NUCLEAR ENERGY INSTITUTE

April 26, 2001

Comments on
NUREG-1738 Technical Study of Spent Fuel Pool Accident Risk at
Decommissioning Nuclear Power Plants

Figure 1

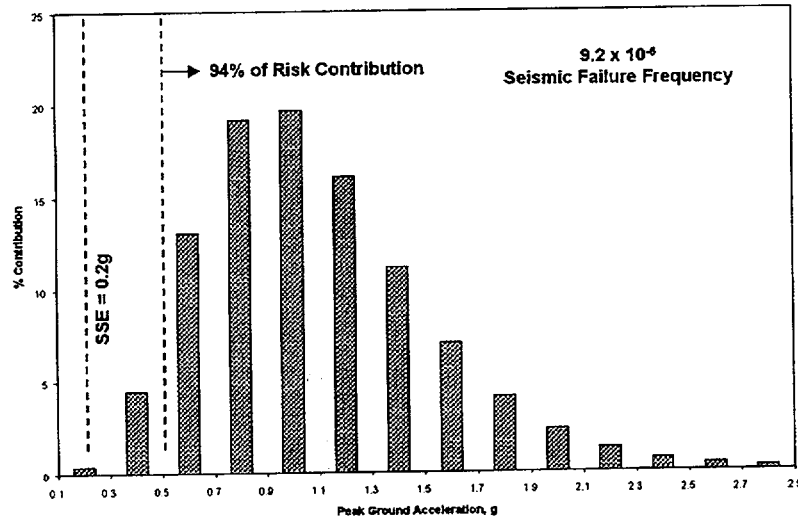
The staff extended LLNL seismic hazard curves beyond the return periods typically used for evaluating seismic risk at operating plants and requested that industry provide similar extensions for EPRI seismic hazard curves for the purpose of the spent fuel study. Figures 1-3 show the distribution of seismic risk across peak ground accelerations for spent fuel pools at three sites on the east coast. Note that for the Surry pool the 50th percentile of the annual probability of exceedance is 1 in a million years between peak ground accelerations of .5 and .6 g. In fact, the preponderance of the seismic risk is attributable to very low probability very large seismic events. For Surry an examination of Figure 3 reveals that 95% of the risk occurs at levels in excess of 0.5 g, 3 times the safe shutdown earthquake (SSE) for this plant; 60-plus% of the risk comes from seismic events exceeding 1.0g, 4-5 times the SSE for this plant.

Seismic failure frequency is calculated by integrating the product of the conditional probability of failure (called seismic fragility) and the frequency of occurrence of earthquakes over all values of peak ground acceleration. This procedure is called "convolution". For example, the mean seismic failure frequency of spent fuel pool structure at Robinson is calculated as 9.2×10^{-6} per year. This value includes contribution from different levels of ground acceleration. The above plot shows this contribution. For example, about 4 percent of the failure frequency is contributed by earthquakes in the range of 0.3g to 0.5g peak ground acceleration. It can be seen that 94 percent of the failure frequency comes from earthquakes with peak ground acceleration in excess of 0.5g. This situation arises from extrapolation of the hazard curves beyond the range of empirical evidence and the large uncertainty that the experts associate with the hazard at higher ground motion levels. It is comforting to observe that the spent fuel pool structure does not have seismic vulnerability at earthquakes less than 0.5 g peak ground acceleration and any upgrading of the structure beyond 0.5 g will not materially reduce the risk at higher levels. Further, the risk from higher levels comes mainly from extrapolations that are highly controversial.

Figure 4

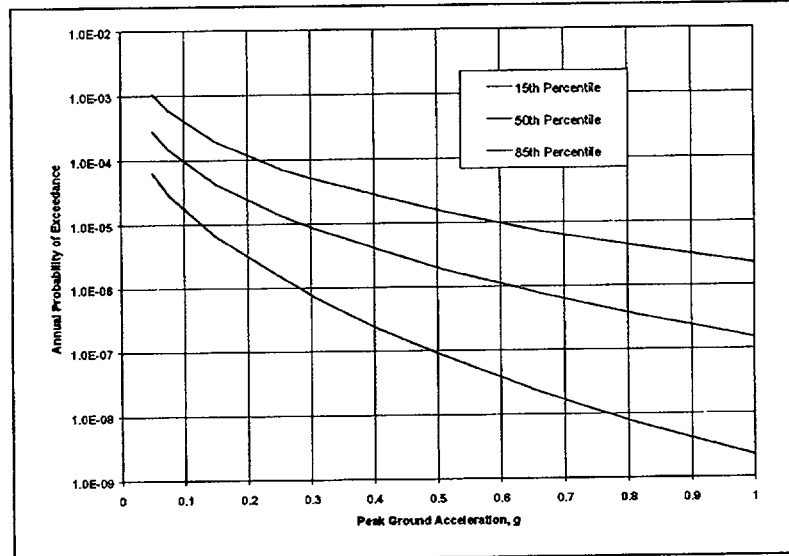
The ability to address seismic events that are not expected to occur is exacerbated by the fact that the tails of the curves are driven by uncertainty. For example, an examination of Figure 4 reveals that uncertainty increases from a factor of 10 in the realm of plausible earthquakes to a factor of 1600 at earthquakes of 1.0g. The diverging nature of the uncertainty curves means that real improvements in seismic capacity will be masked by uncertainty, as seismic events become larger, and more implausible. In addition, risk estimates are likely to be highly overly conservative at the high ground motion levels predicted for seismic events of this size.

Probabilistic analyses should be performed because these analyses define the upper boundaries.¹ However, a lower limit based on curves that are truncated at certain very low return frequencies, should be employed for regulatory decision making regarding the need for protection requirements. For example, risk estimates for regulatory purposes based on return frequencies not exceeding E4 –E5 at the 50th percentile makes it clear to stakeholders that very low frequency events are outside the boundaries for practical decision making.
